Riverside Center

Critique of Proposed Extell Development

Community Board 7, Mel Wymore, Chair

Riverside Working Group, Ethel Sheffer, Chair

RIVERSIDE CENTER – PROPOSED SITE PLAN

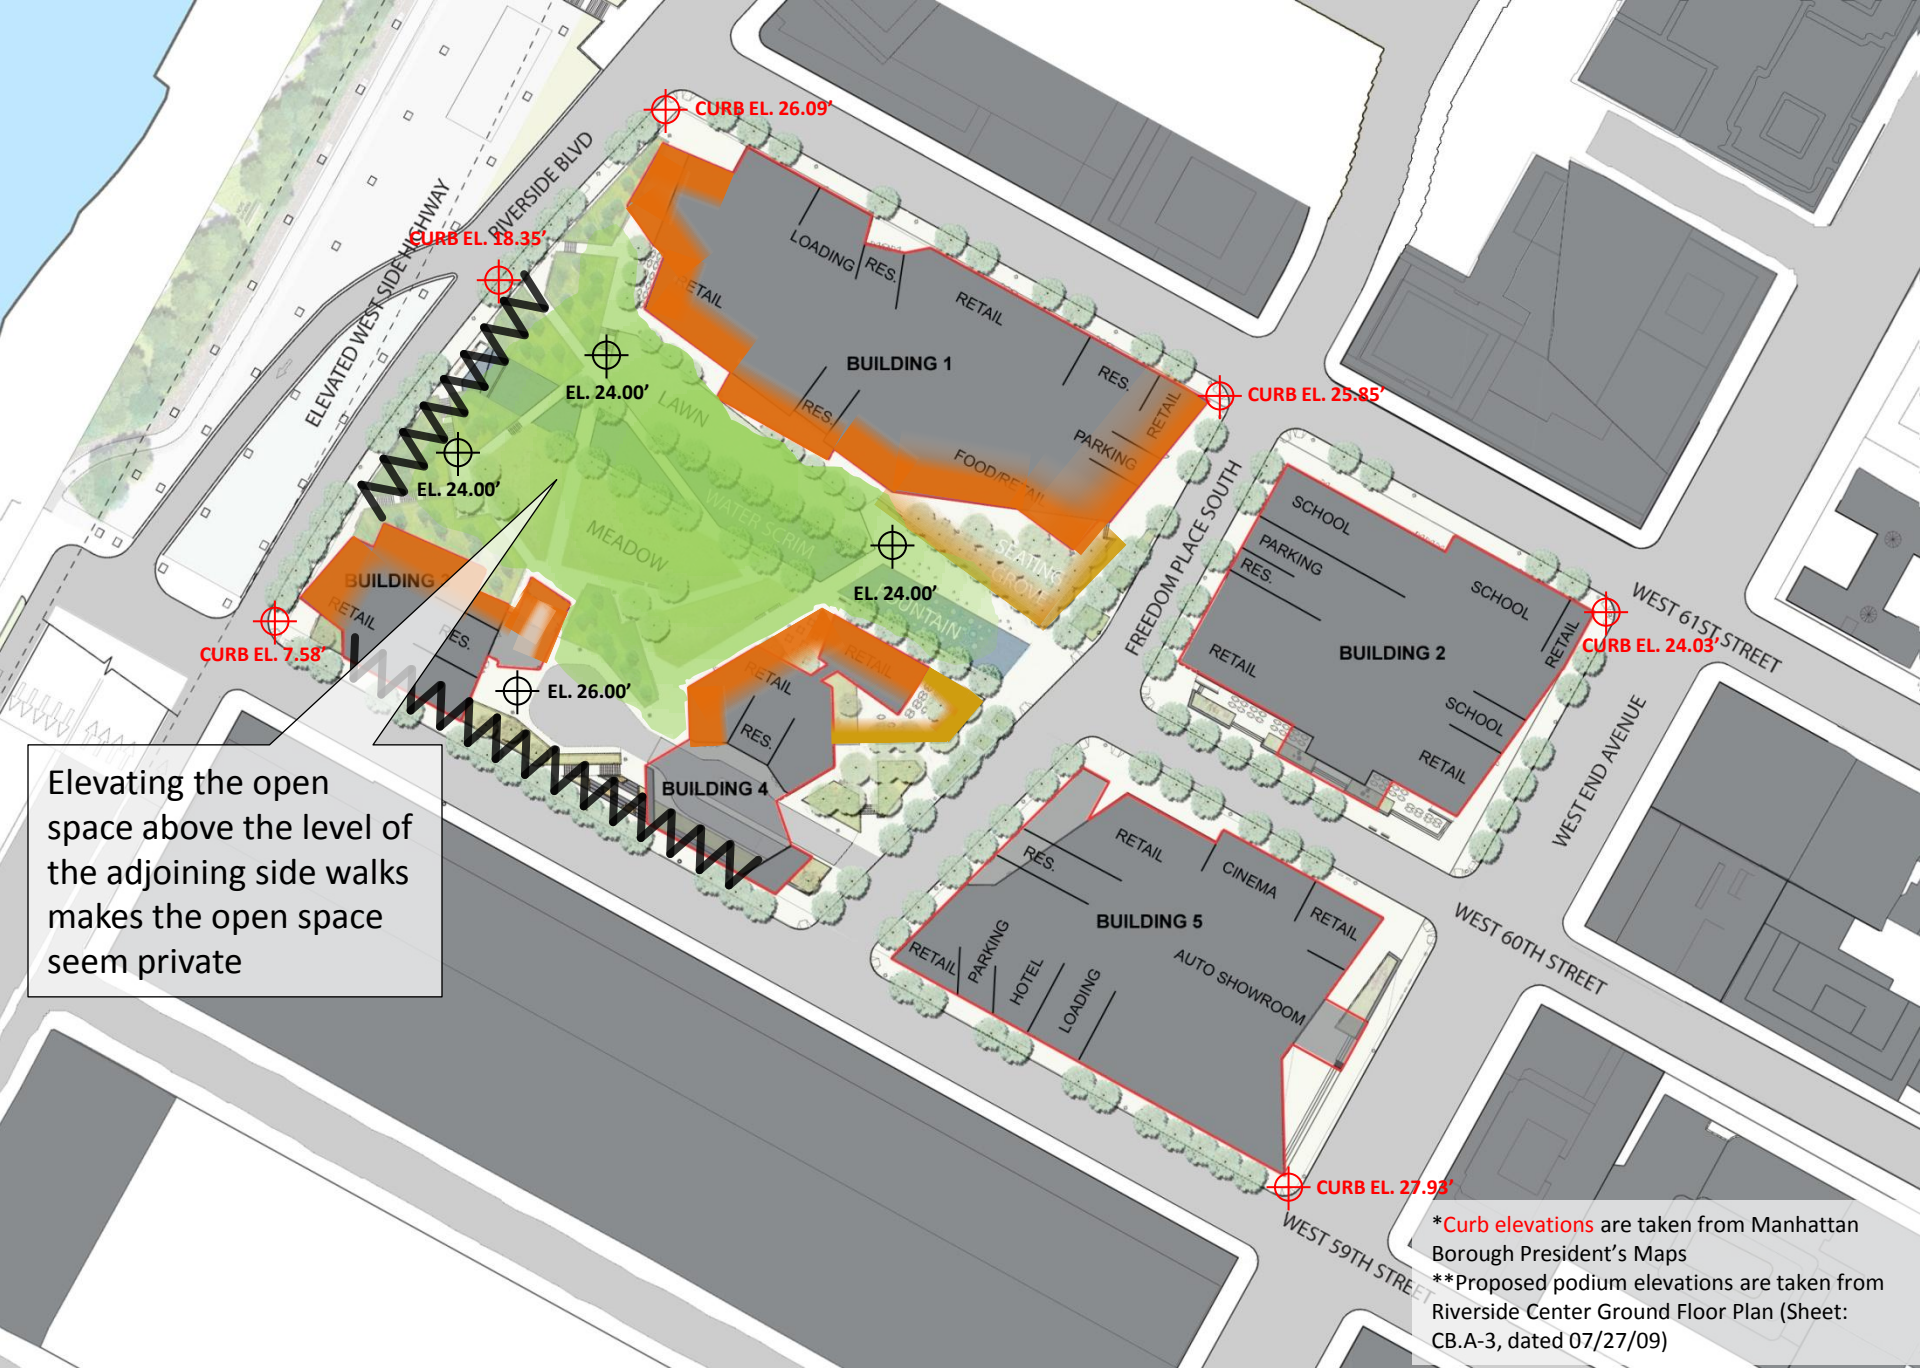
Elevating the open space above the level of the adjoining side walks makes the open space seem private

Lobbies of buildings 1,3 and 4 face the open space, making it seem like a private front yard.

60th Street dominated by water scrim at Freedom Place, which restricts use and makes space seem private.

The tunnel-like entrance under the building cantilever makes the open space seem private.

The narrow opening and elevated private café's between buildings 1 and 4 acts as a gate, which makes space seem private.

Open Space is Limited

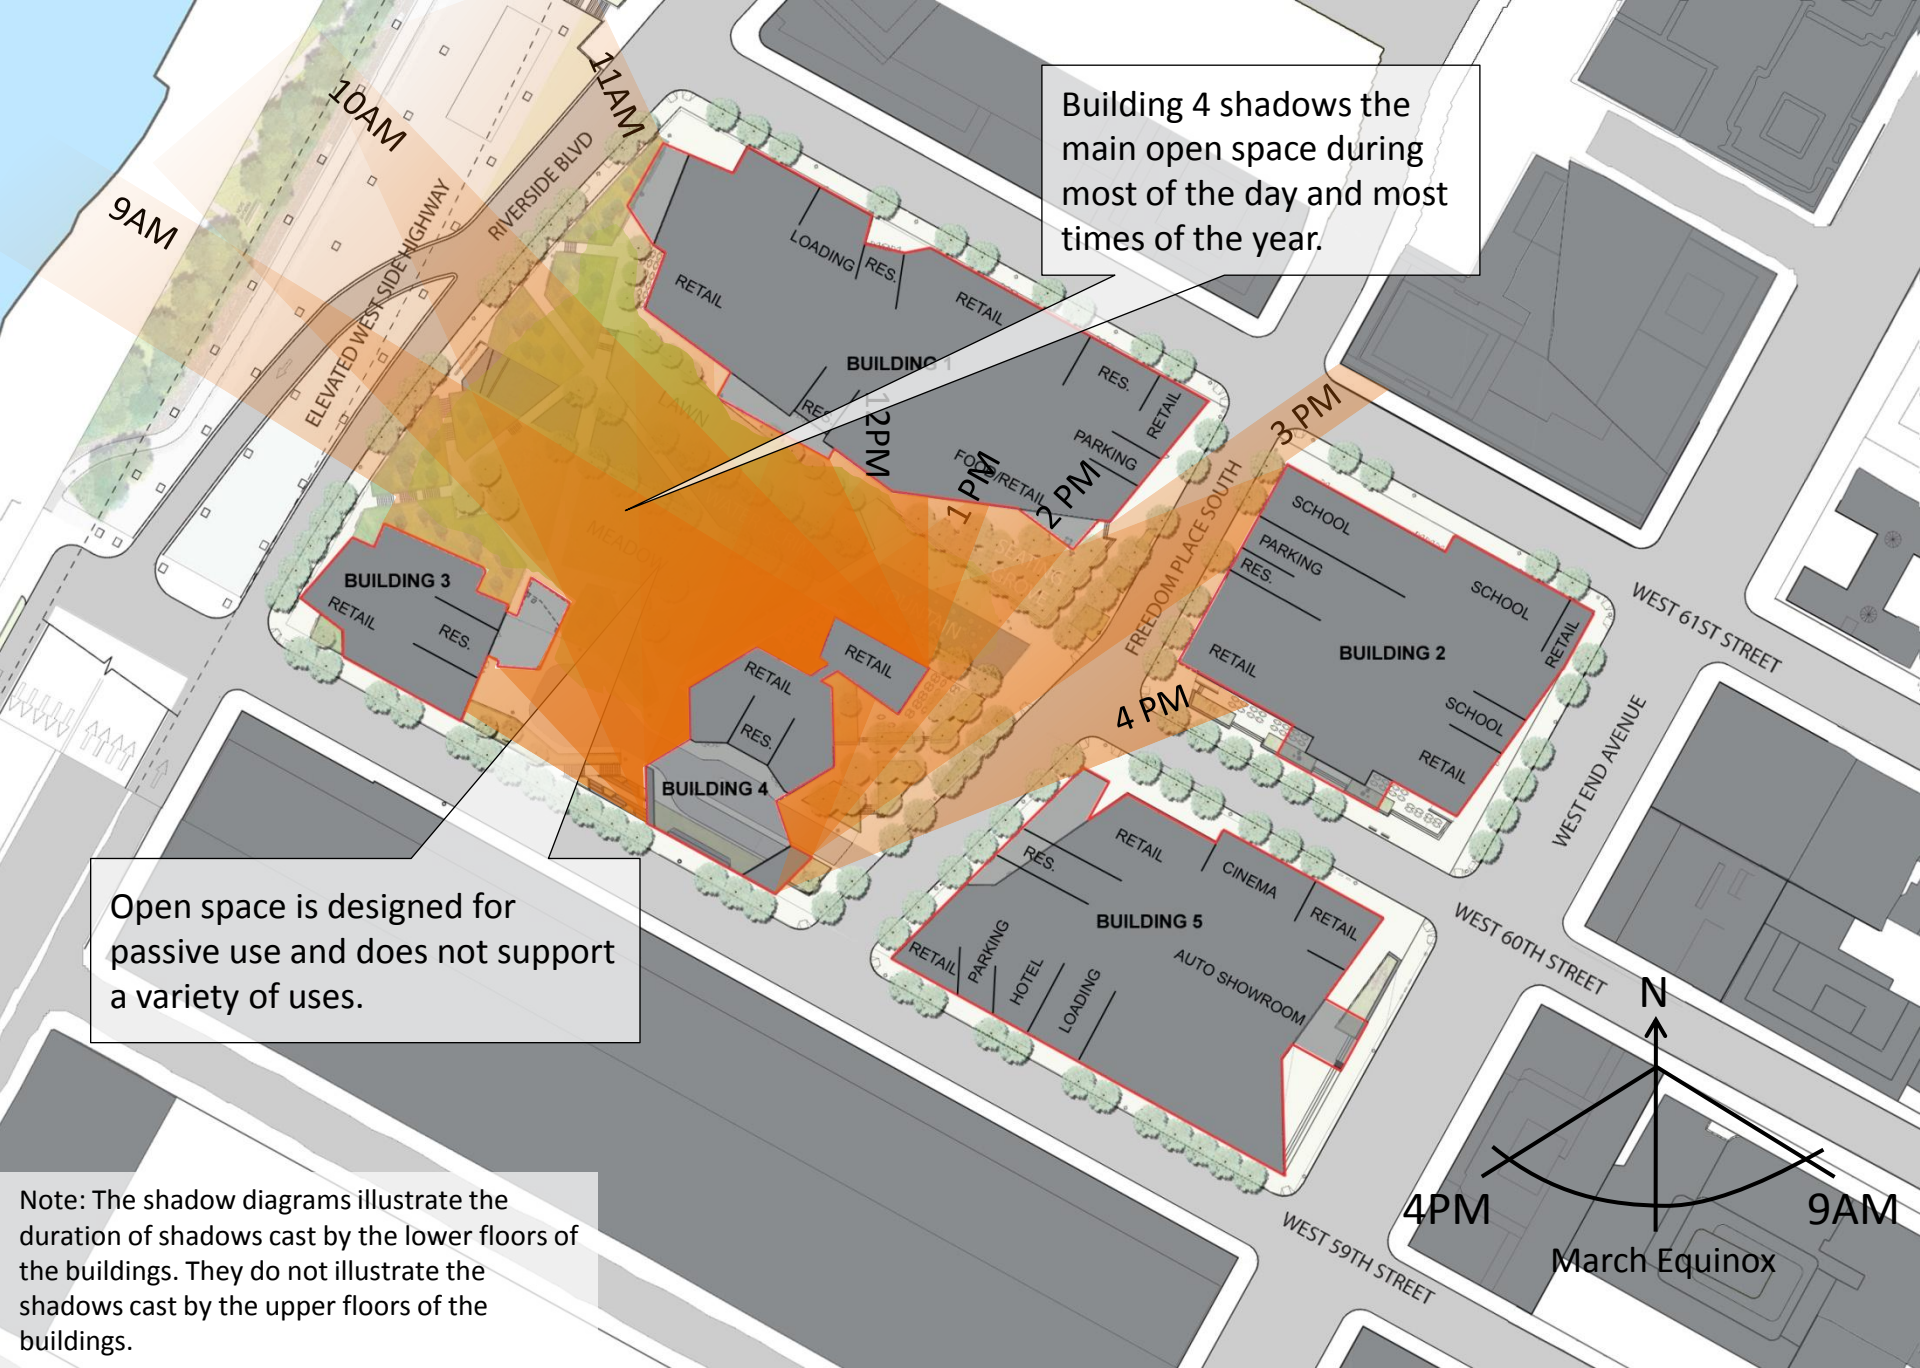
Open space is designed for passive use and does not support a variety of uses.

Building 4 shadows the main open space during most of the day and most times of the year.

Access to/from
Riverside South Park is Restricted

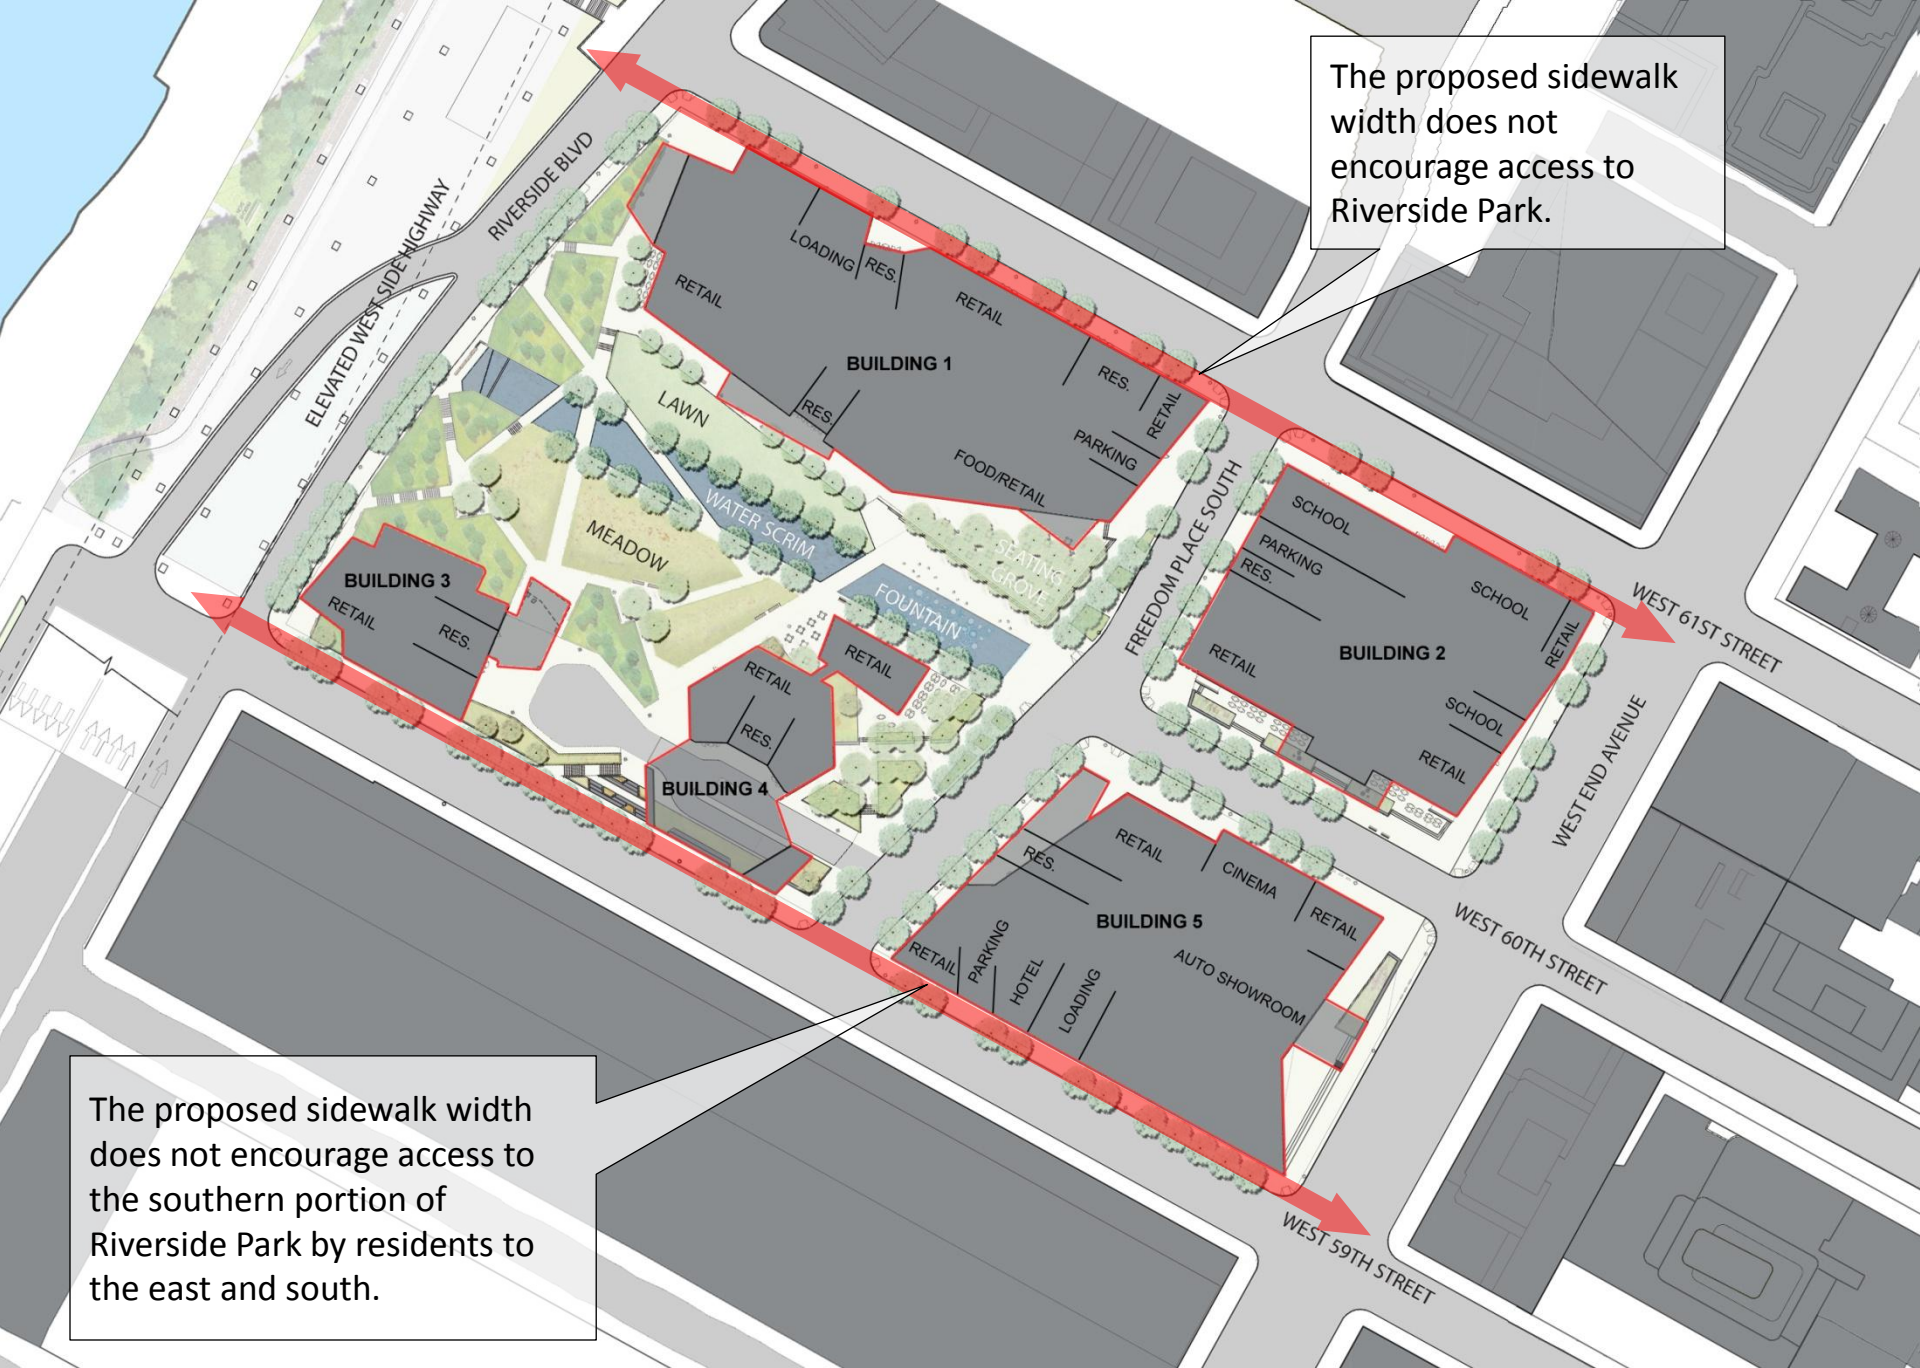
The proposed sidewalk width does not encourage access to Riverside Park.

The proposed sidewalk width does not encourage access to the southern portion of Riverside Park by residents to the east and south.

The complex pattern of paths and stairs discourage circulation to Riverside Park and limit handicap and elderly access.

Streetscapes are Often Neglected

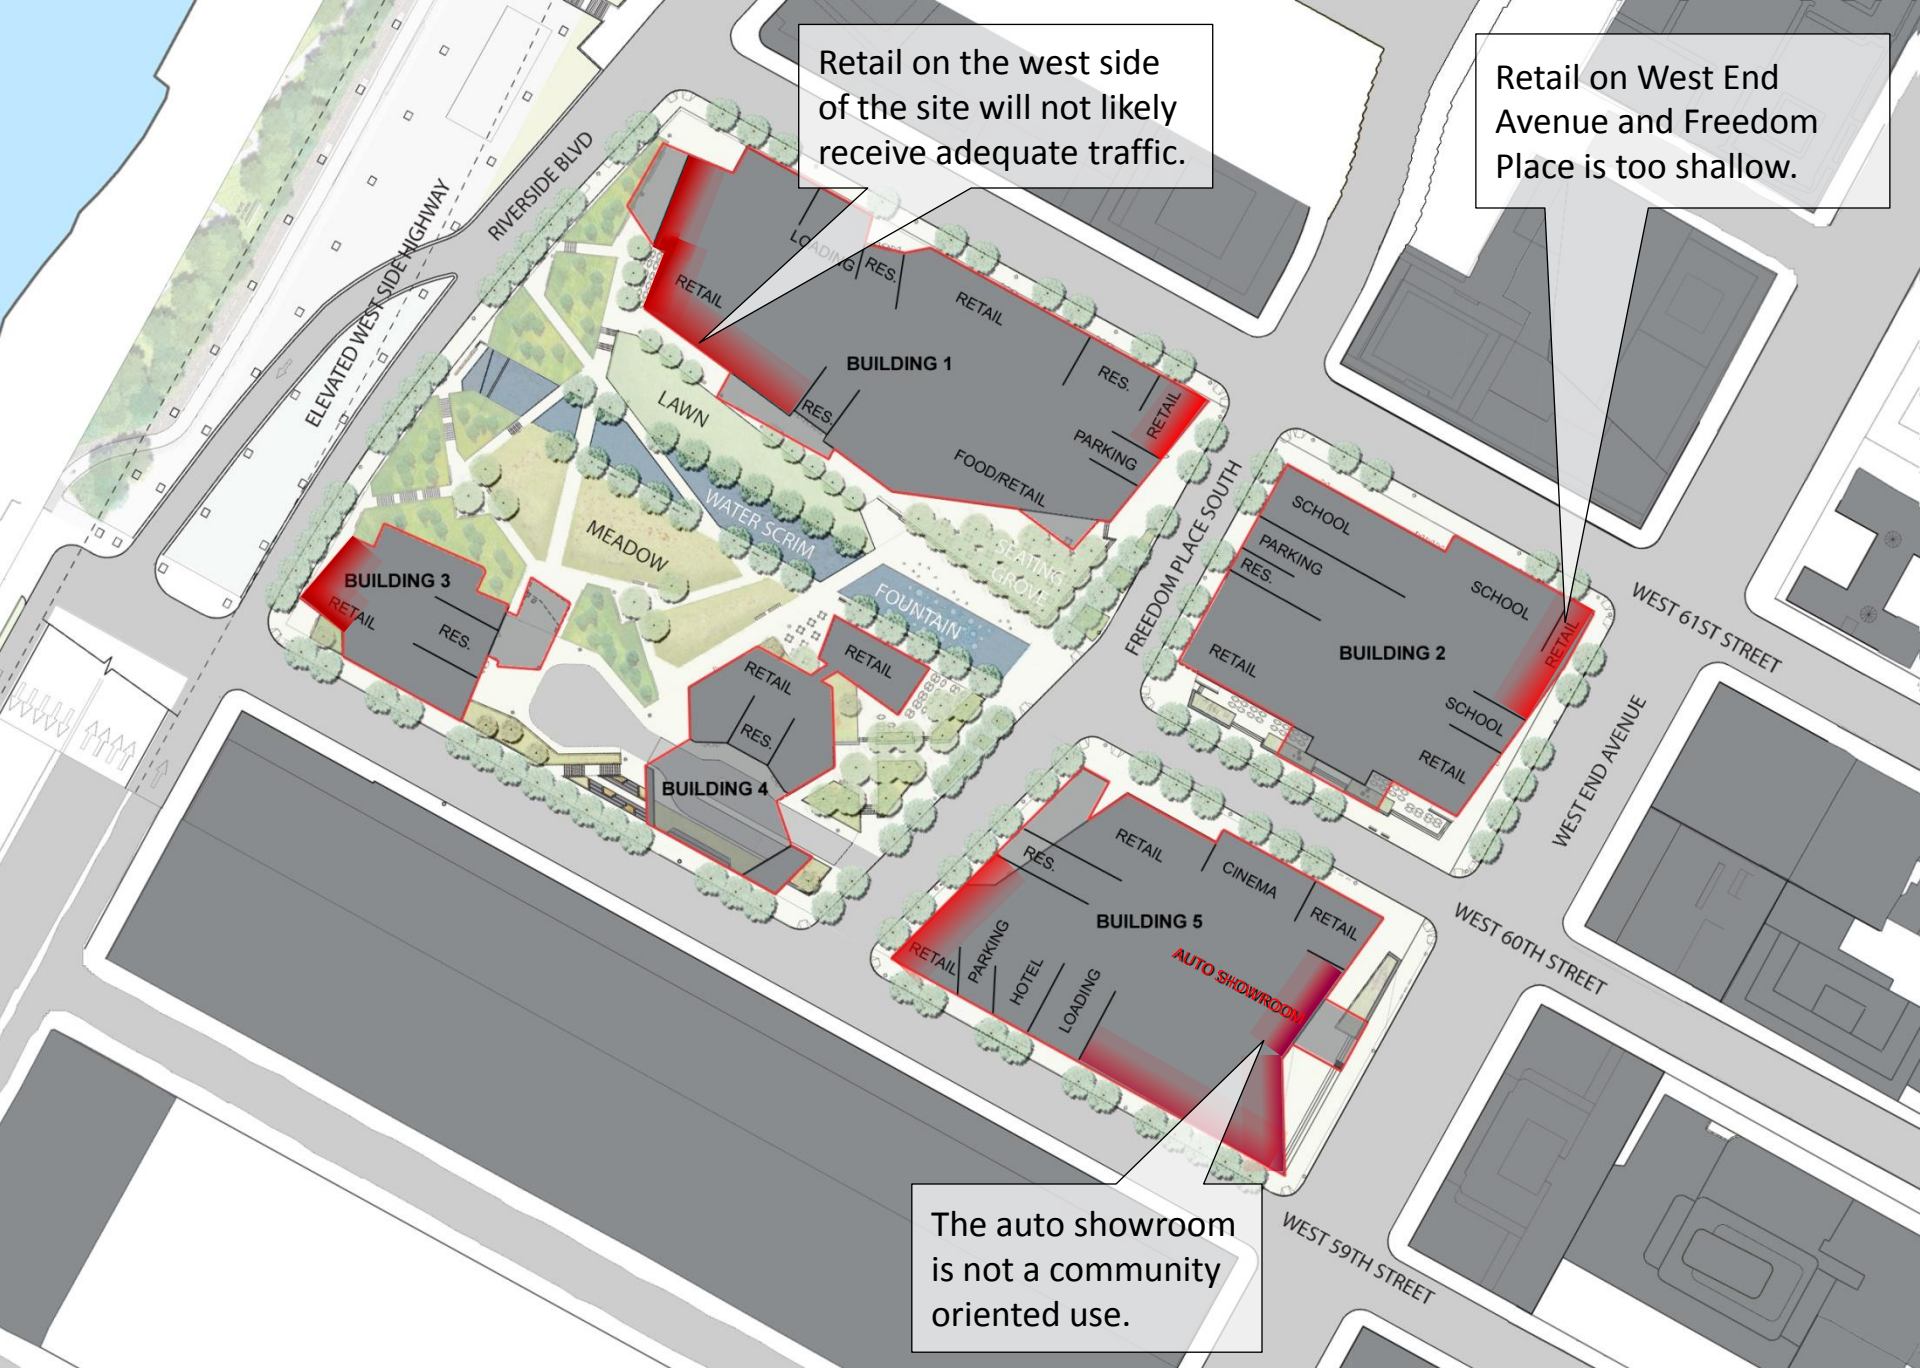
Retail on the west side of the site will not likely receive adequate traffic.

Retail on West End Avenue and Freedom Place is too shallow.

The auto showroom is not a community oriented use.

Some retail frontages are set back on terraces above sidewalk level.
